# Accessibility Evaluation

## Monroe County Polling Location

**Souls Harbor Church**  
**7510 S Old State Rd 37**  
**Bloomington, IN 47403**

**Report Date: 04/07/2026**

### Finding: 1

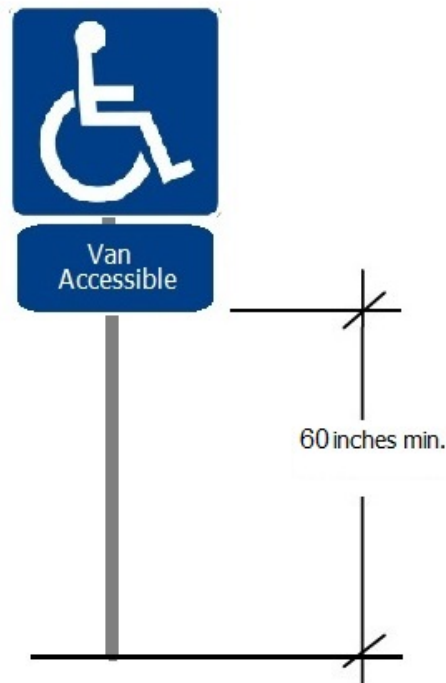
The required parking signage is missing.

The four accessible spaces have no signage. Recommend adding temporary or permanent signs.

### Finding: 2

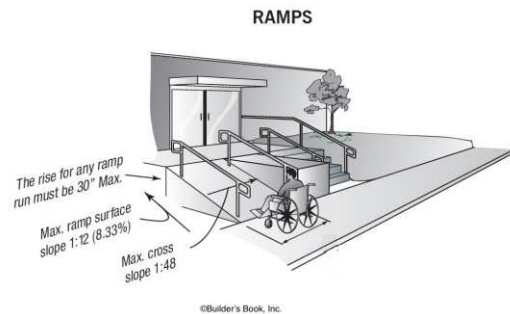
The ramps contains multiple issues.

The ramp contains running slopes greater than 8.3% and 2% cross slope.

The ramp does not have compliant level landings.

The ramp is not the required minimum width.

The ramp does not have compliant handrails with wheel guides.

The ramp surface contains changes in level.

The ramp has no railings and individuals must travel through the path of traffic to reach it. Recommend adding signage directing voters to the front doors as an alternate accessible entry.
